Public Hearing Item 4:
5900 Block Cambie
Rezoning Application -
March 9, 2021

Oakridge Langara Area Residents

Figure 5.15: Representative section of commercial interface with lane, podium height and tower placement

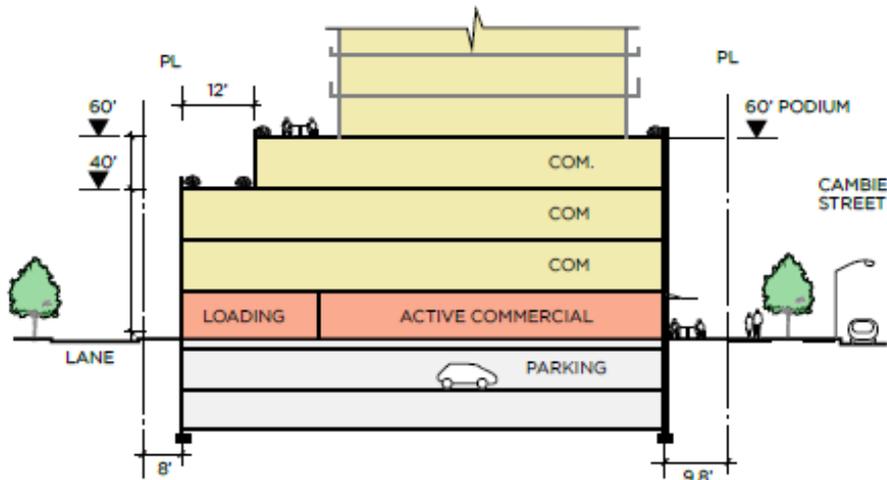
5.3.5 **Above 40 ft** buildings should be **stepped back an additional 12 ft** from the lane. See Figure 5.15 [beside].

Proposed Condo Tower

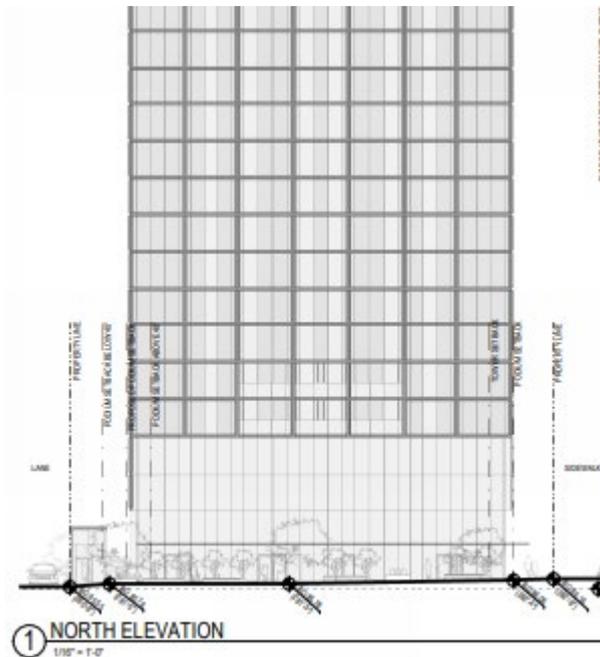
- While two stepbacks are directed for residential towers on the lane, **none** are proposed
- Is continuous vertical expression maximizing the bulk & oppressiveness of the tower

5900 Block Cambie Proposed Plaza

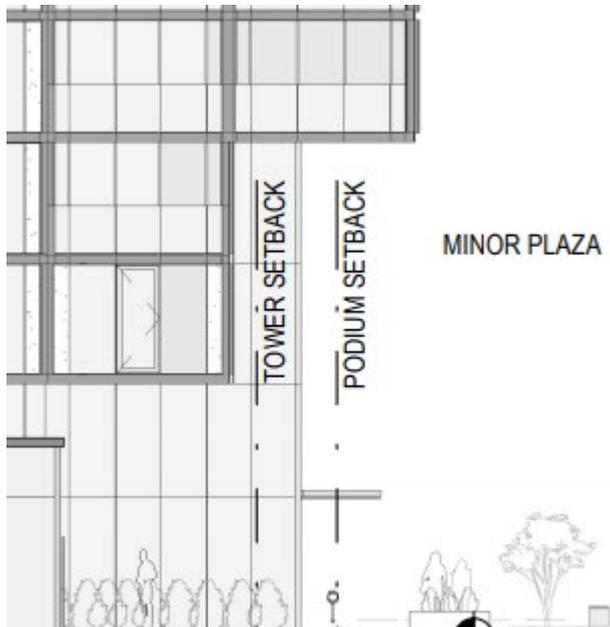
- Tower overhangs public plaza
- Partial plaza ceiling causes feeling of being closed in
- Tower too wide and FSR too high
